MED - 42 - 2.47

SUBSUMMARIES

2020-11-10: ADDENDUM 3 - QUANTITIES UPDATED

**CROSS SECTIONS - U.S. 42
 STA. 130+00.00 TO STA. 130+64.45**

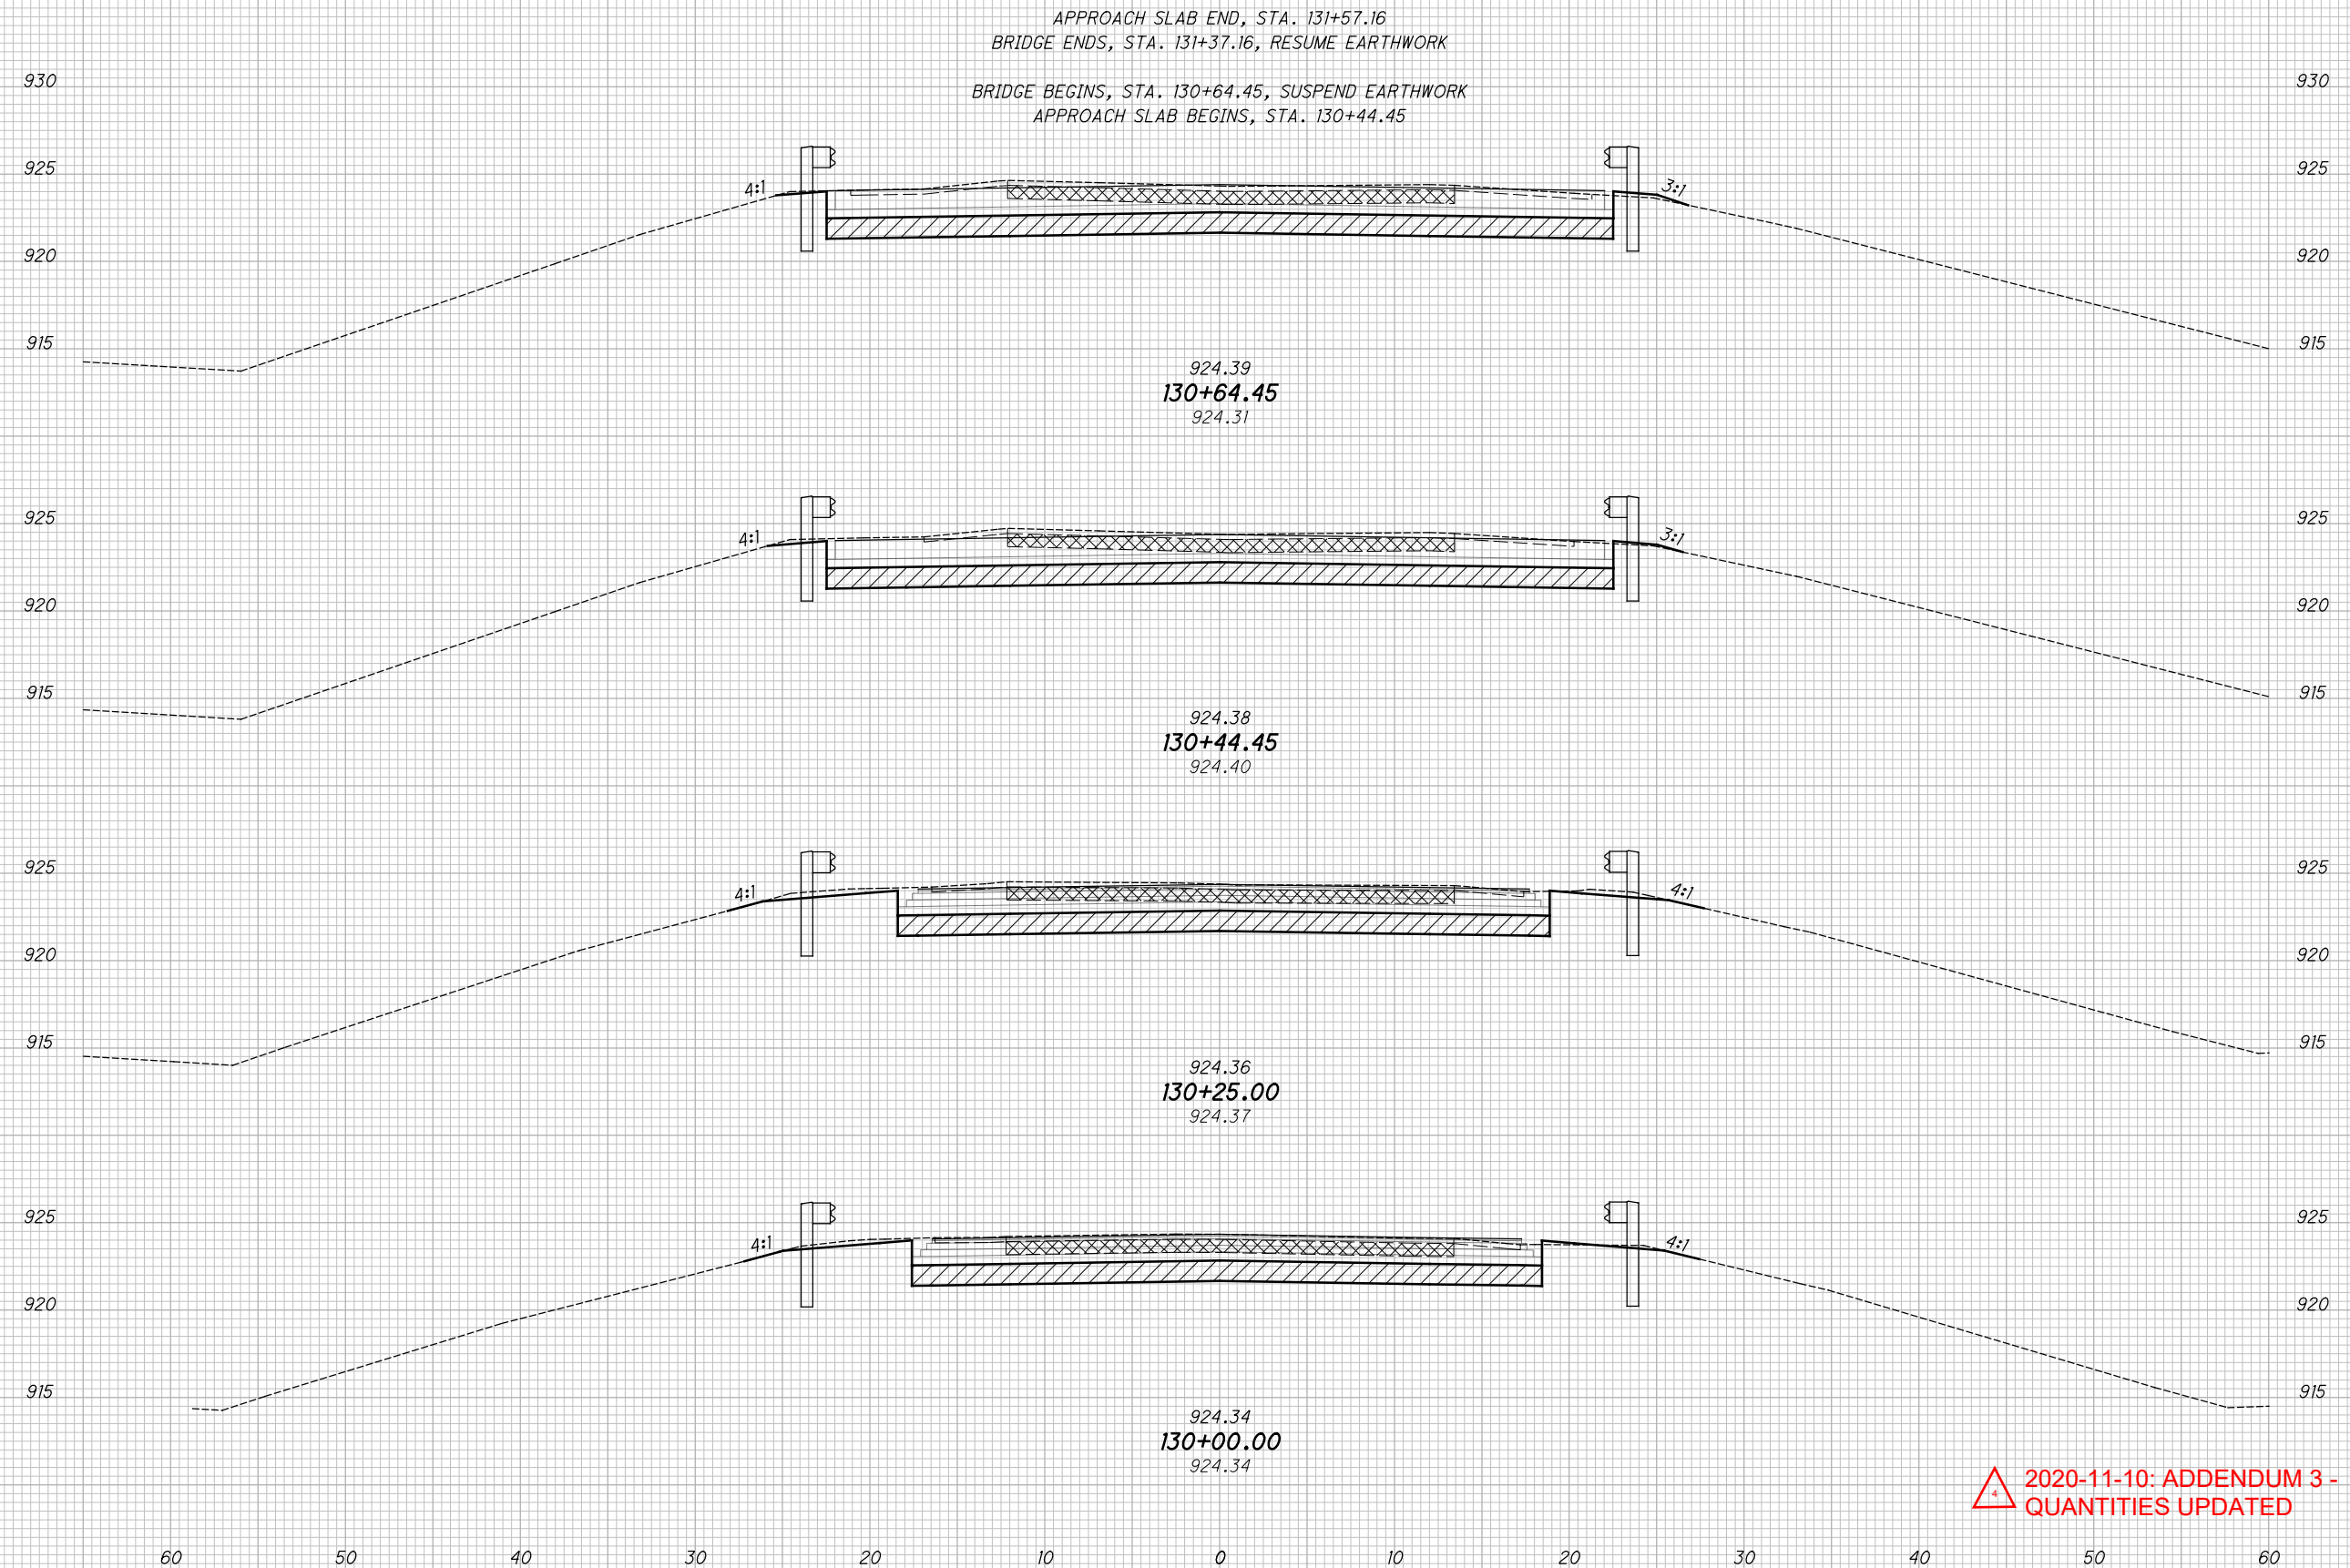
2020-11-10: ADDENDUM 3 - QUANTITIES UPDATED

CROSS SECTIONS - U.S. 42
STA. 131+37.16 TO STA. 132+07.16

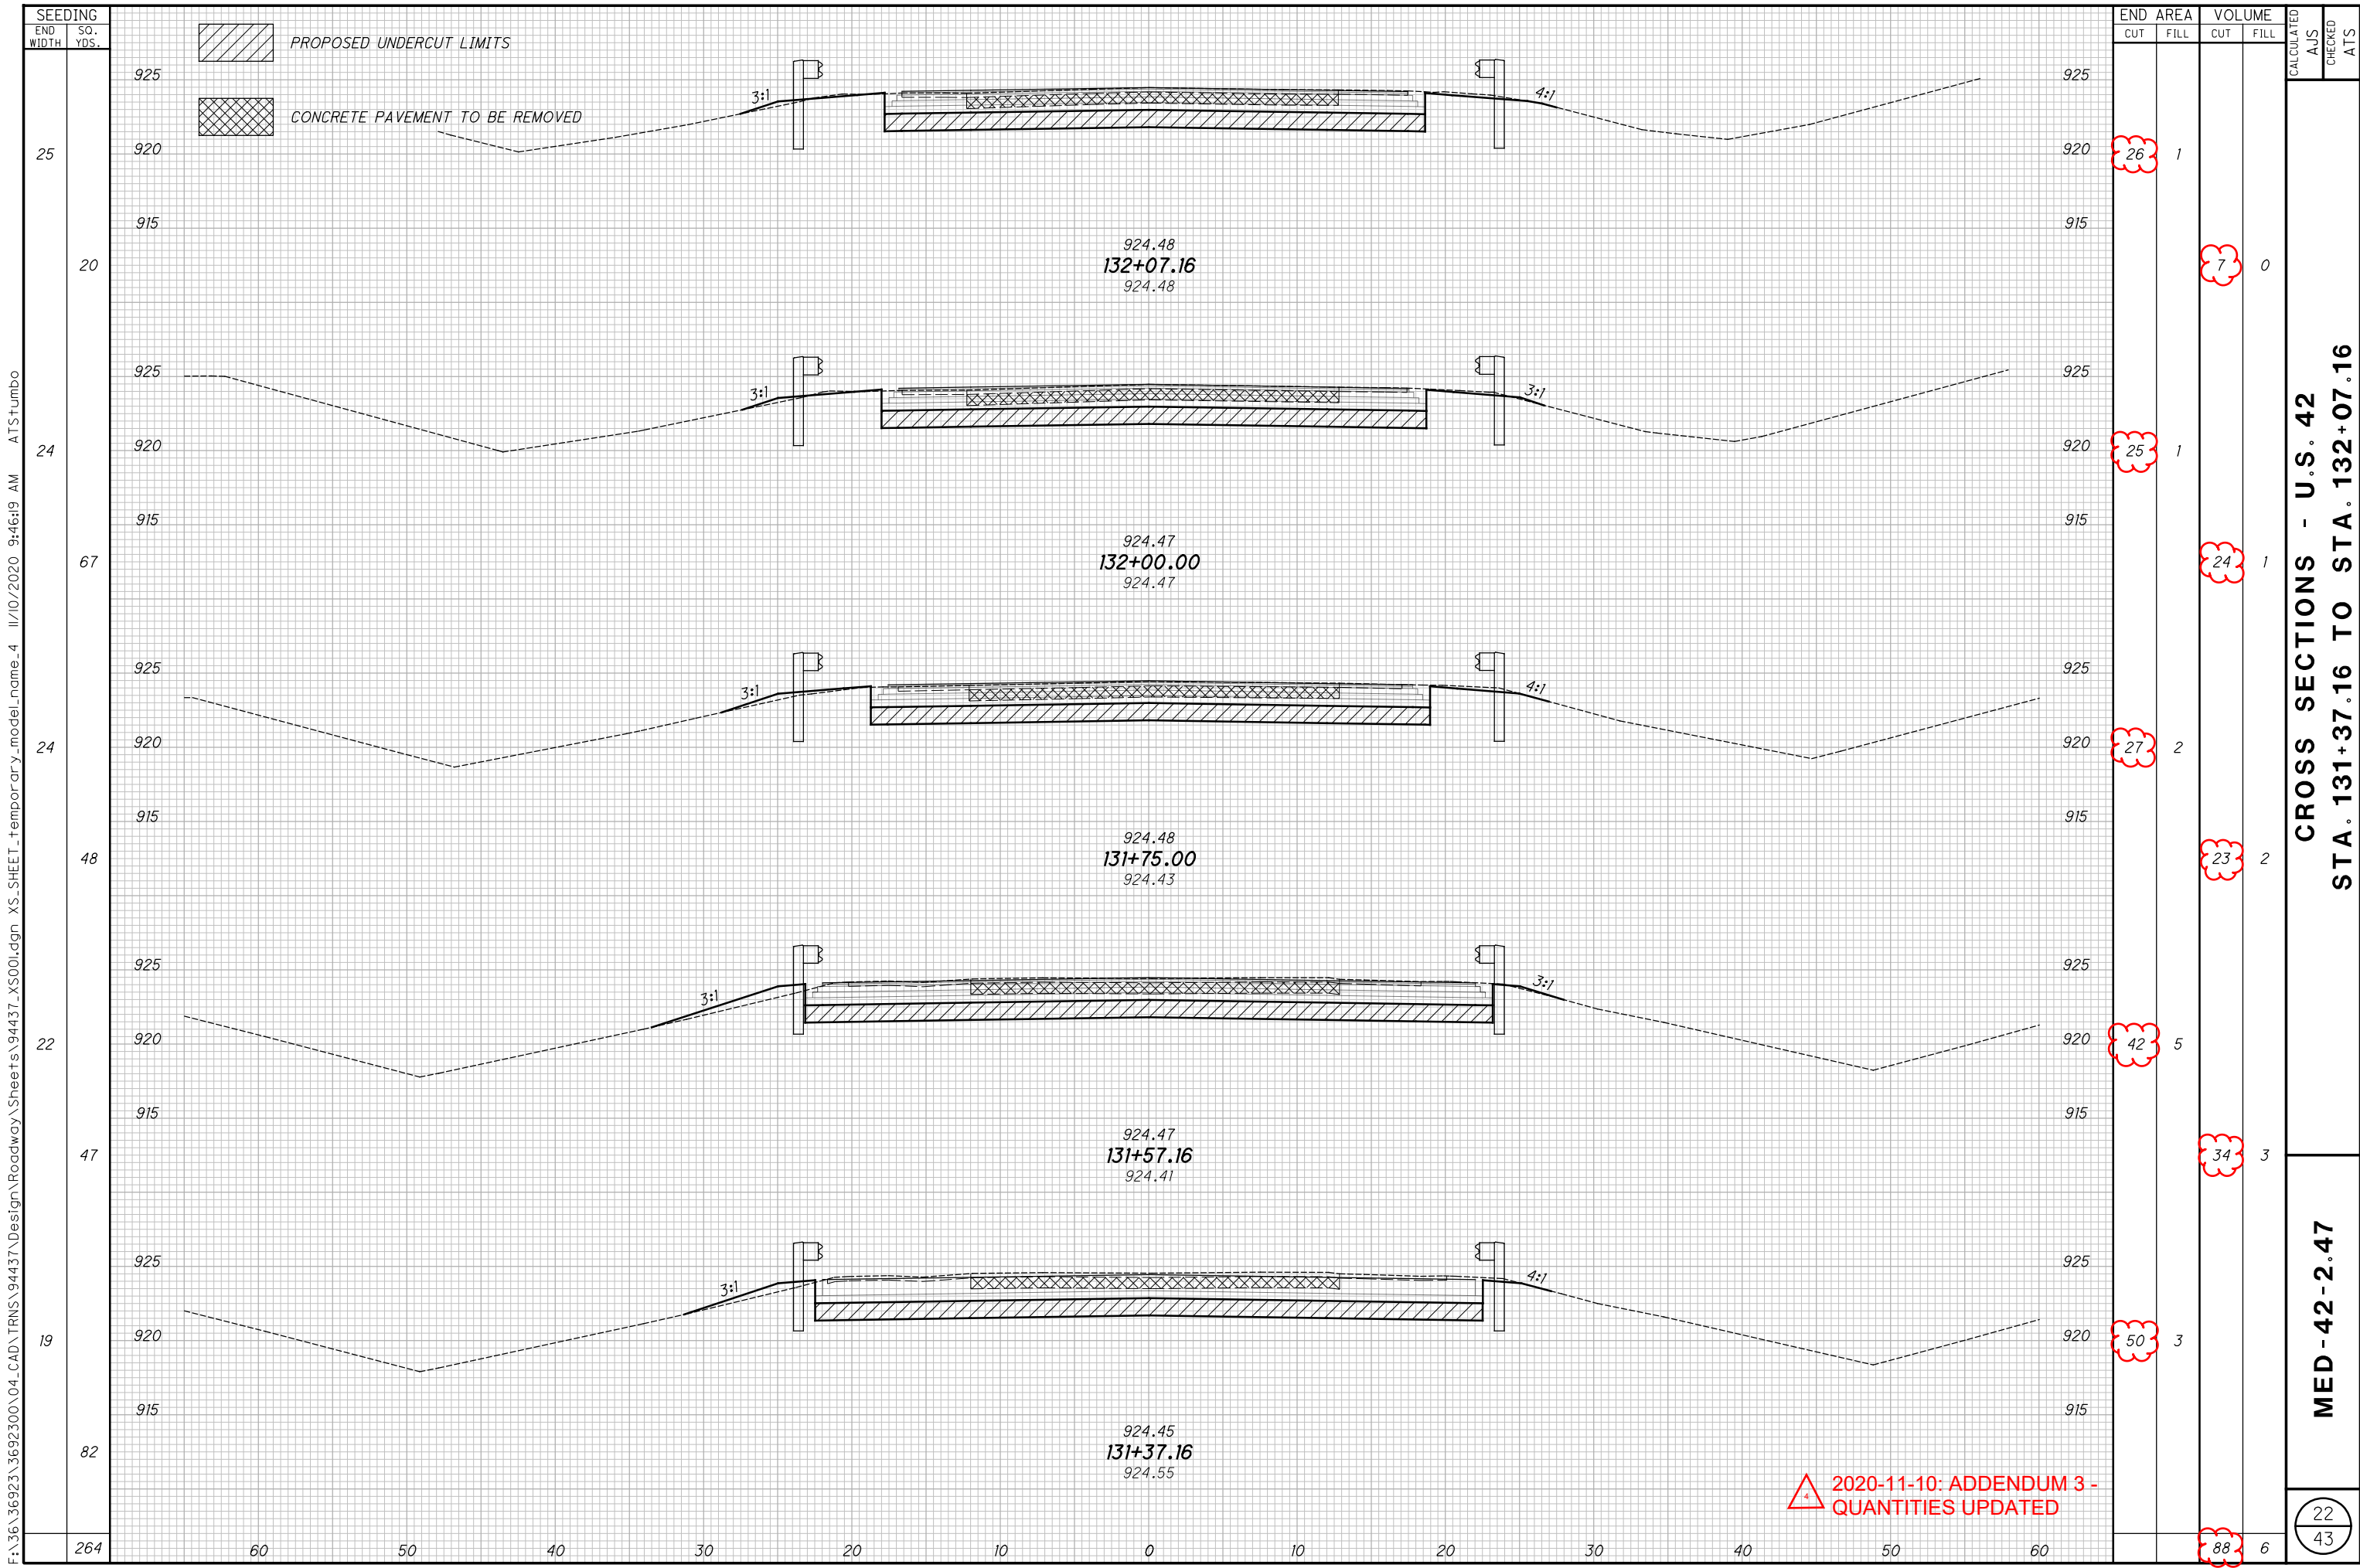
▲ 2020-11-10: ADDENDUM 3 - QUANTITIES UPDATED

**CROSS SECTIONS - U.S. 42
STA. 132+25.00 TO STA. 133+25.00**

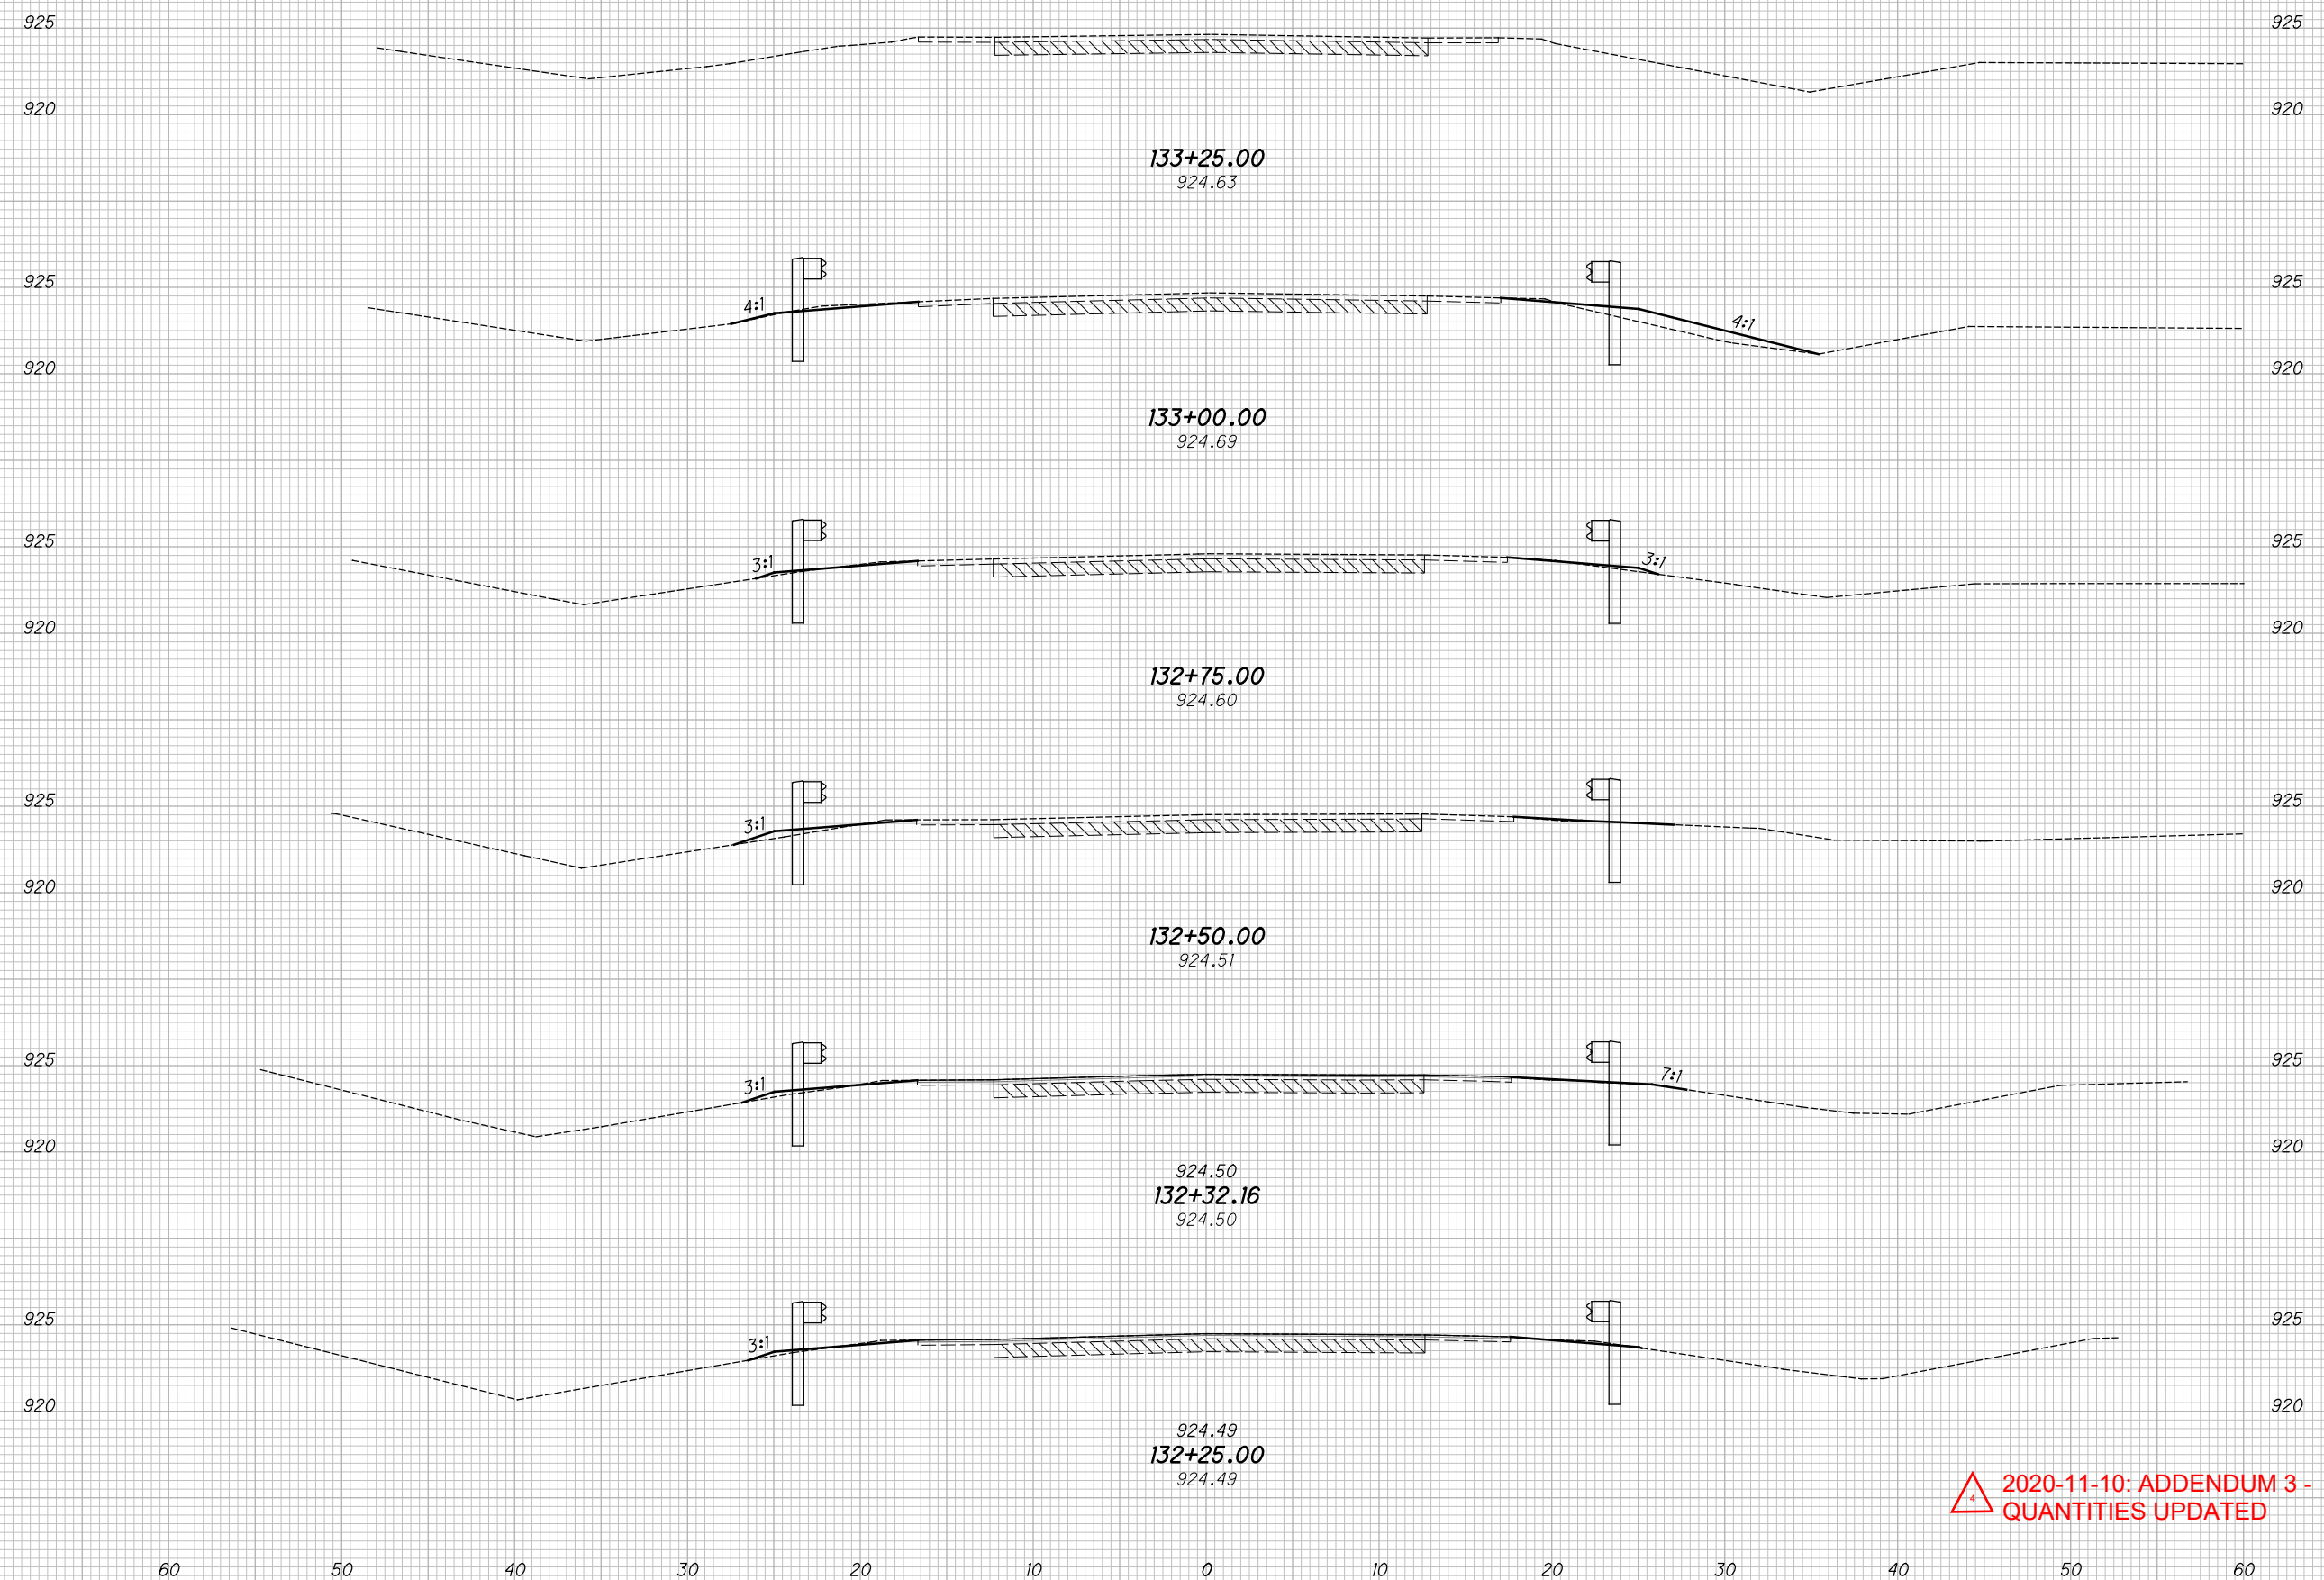
2020-11-10: ADDENDUM 3 - QUANTITIES UPDATED
